From: Peter Langtry [plangtry@cornerstoneearth.com]
Sent: Monday, October 10, 2011 1:27 PM
To: Wickham, Jerry, Env. Health
Cc: nallen@sandis.net
Subject: RE: Ashland Youth Center - Soils Excavation - Additional Area

**ASHLAND YOUTH CENTER
16335 EAST 14TH STREET
CALIFORNIA**

**SOILS MANAGEMENT EXCAVATION
WORK PLAN**

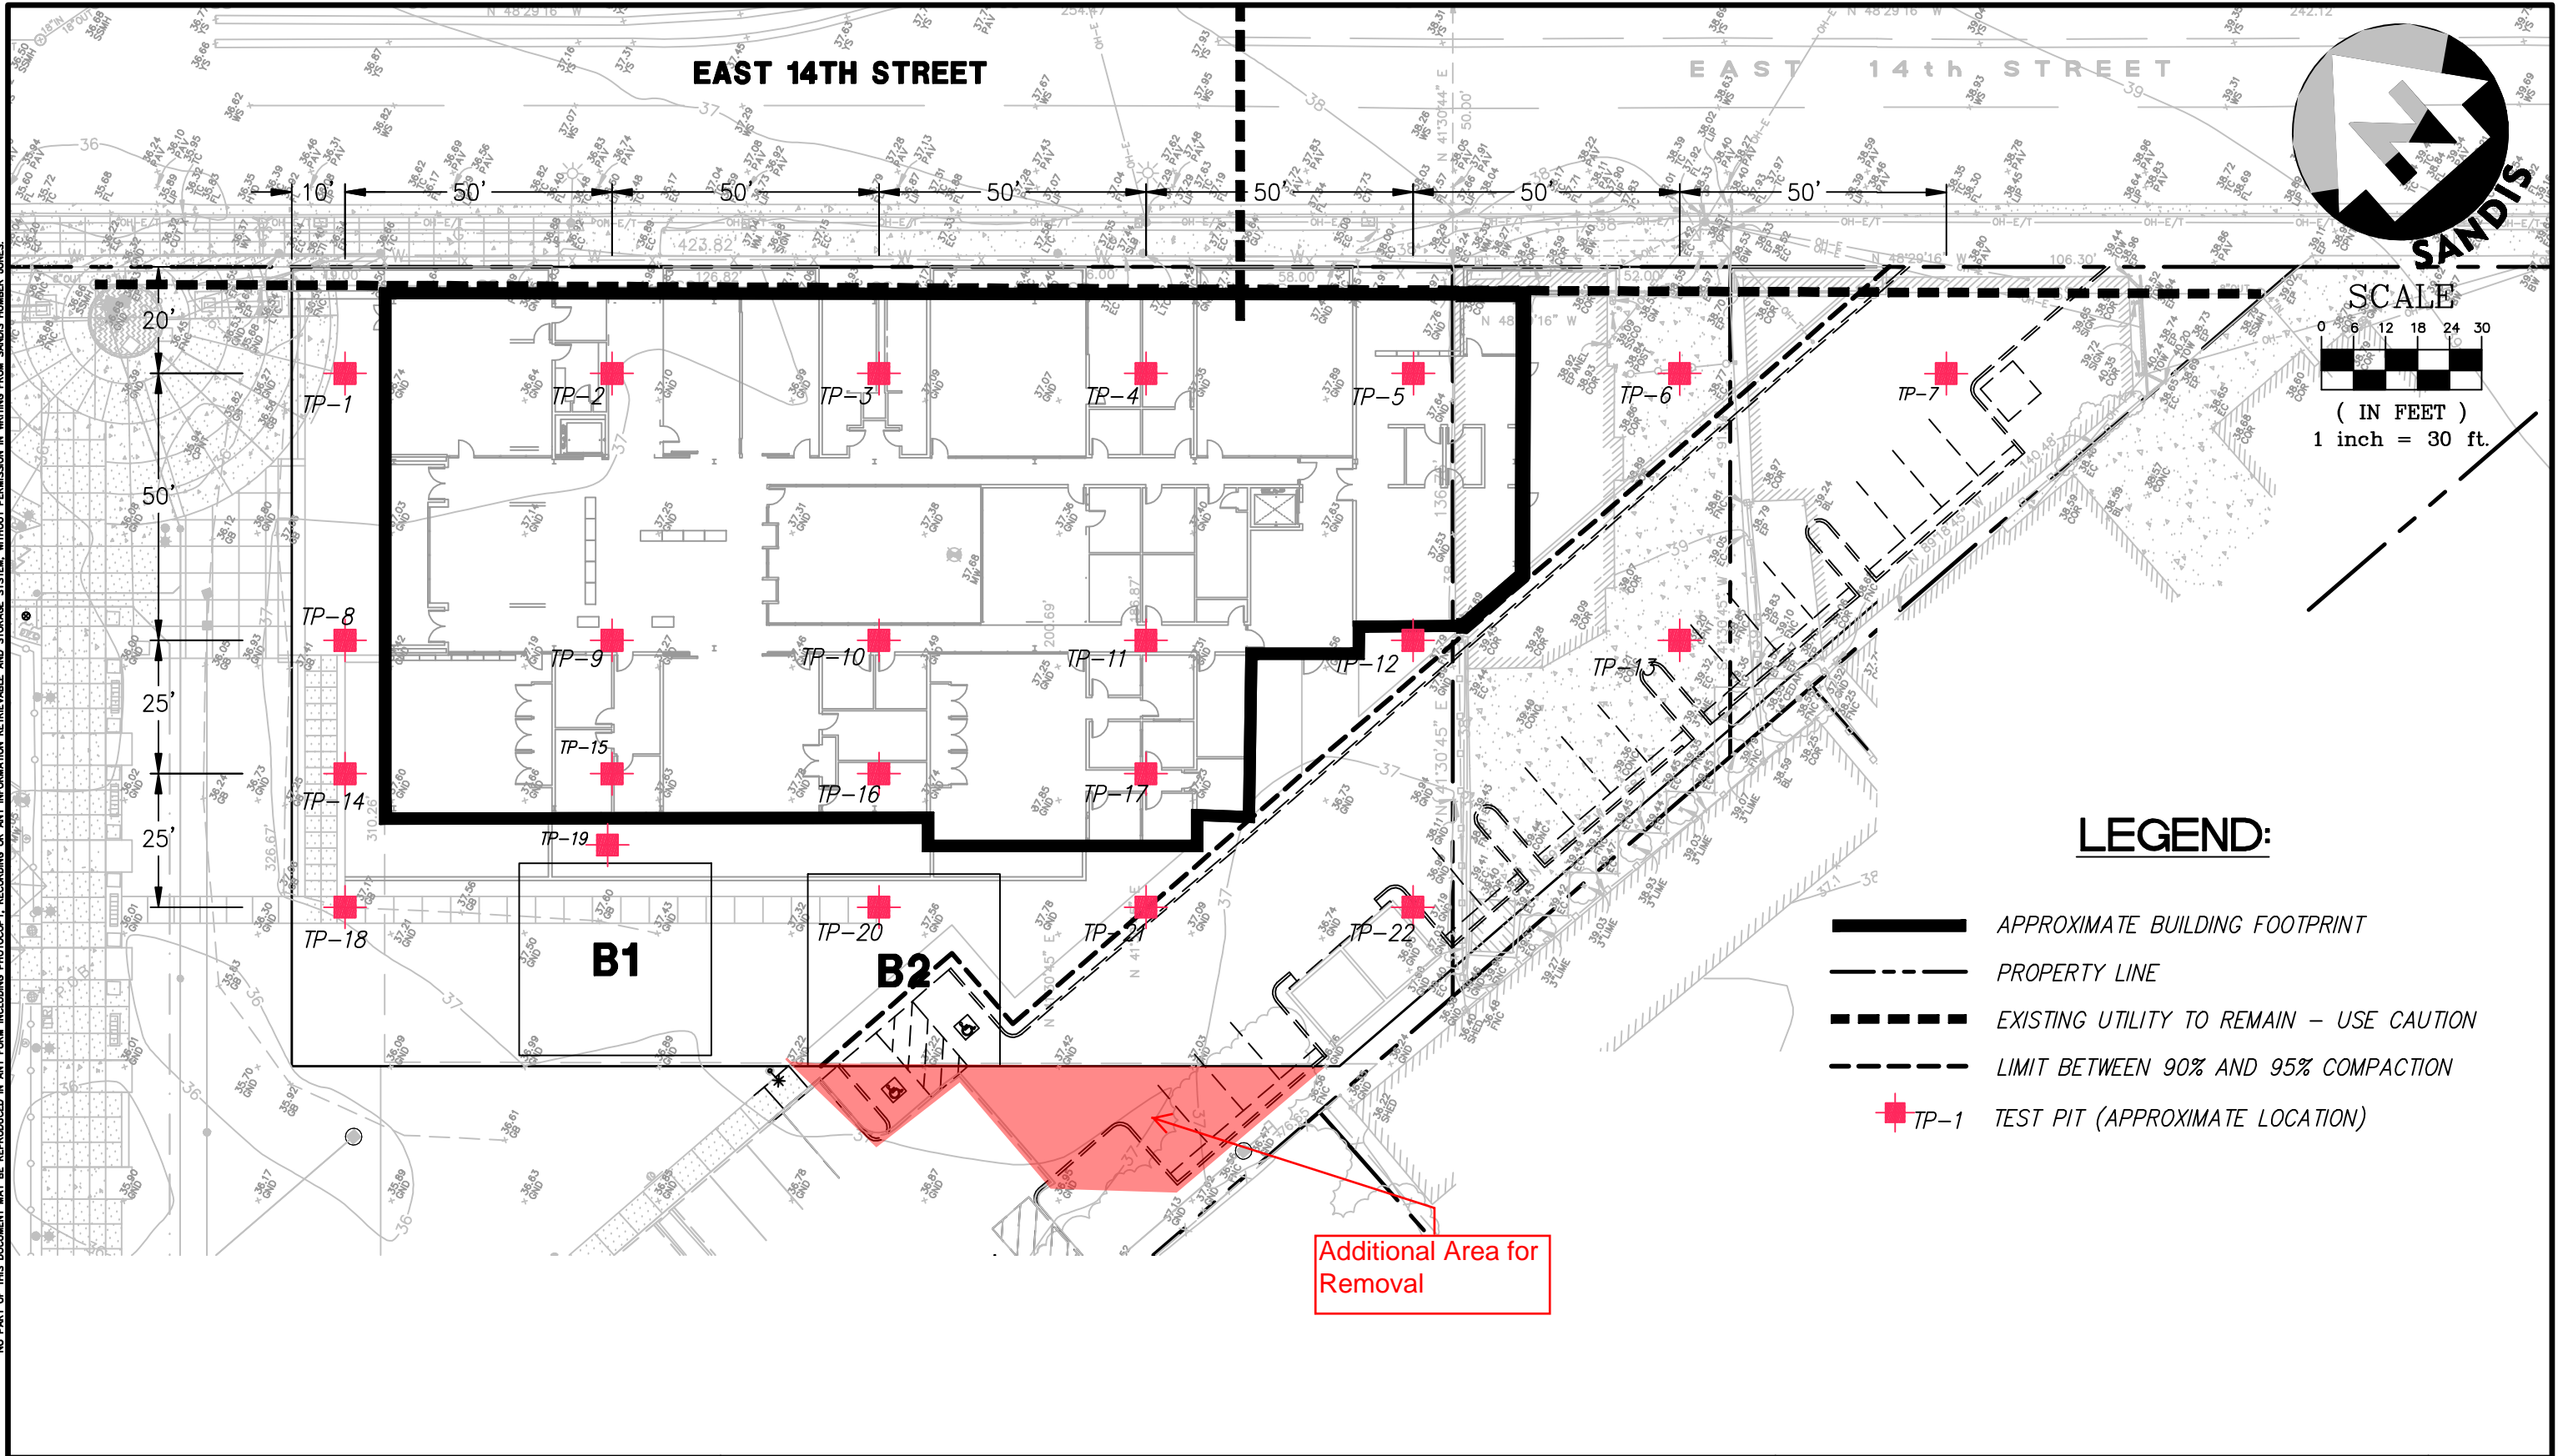
Hello Jerry, Alameda County GSA is considering excavating soil from an adjacent area on the HARD property where parking lot construction will be performed during construction of the youth center. The approximate area is shown on the attached site map. Excavation to a depth of approximately 3 feet is anticipated to help reduce the potential for construction workers to encounter soil with residual COCs during construction.

The additional area is within the area of the HARD property previously excavated to a depth of approximately 1 foot for the prior cleanup activities, so the new excavation would be more for soil management purposes. Would you want to see verification soil samples from this area after the excavation? In addition, would you need to see an addendum to the soil excavation work plan?

Given that the excavation is for soil management purposes, verification sampling would not be required. To formalize the request and approval, I would like to have an addendum in the form of a brief letter with the attached figure.
